March 2019
FL782A-R
NHTSA #18V-503
Transport Canada #18-395
REVISED NOTICE

Subject: Detroit Steer Axle Tie Rods

Models Affected: Specific Freightliner 114SD, Business Class M2, Cascadia, and Coronado vehicles, and Western Star 4900 vehicles manufactured July 1, 2011, through January 30, 2014.

Fig. 1, Tie Rod Assembly

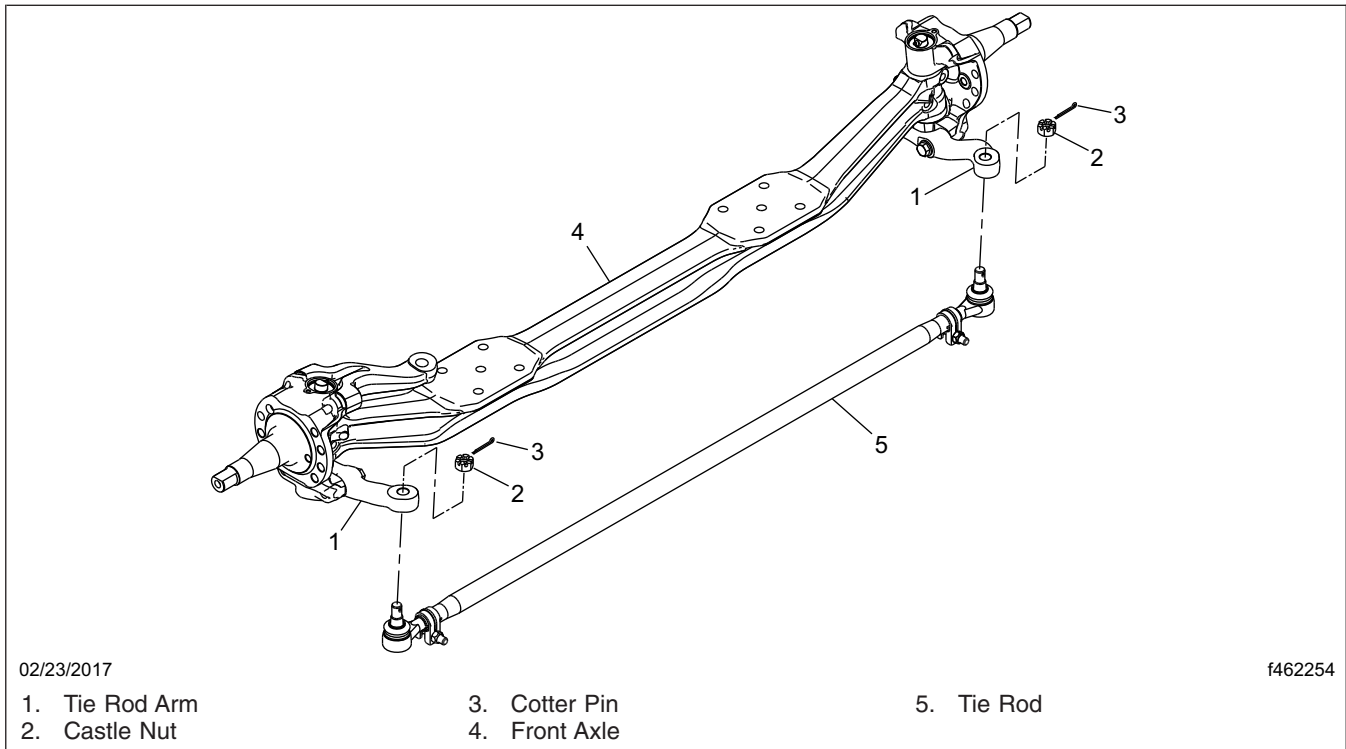
7. Disconnect the tie rod from the tie rod arms; see [Fig. 1](#). Remove the tie rod from the vehicle and discard it.

8. Attach a new tie rod to the tie rod arms. Tighten the castle nut 120 to 170 lbf-ft (163 to 230 N·m) plus a maximum of one-sixth of a turn to align a slot in the castle nut with the cotter pin hole in the tie rod stud. Insert the cotter pin and bend the tangs to secure it.
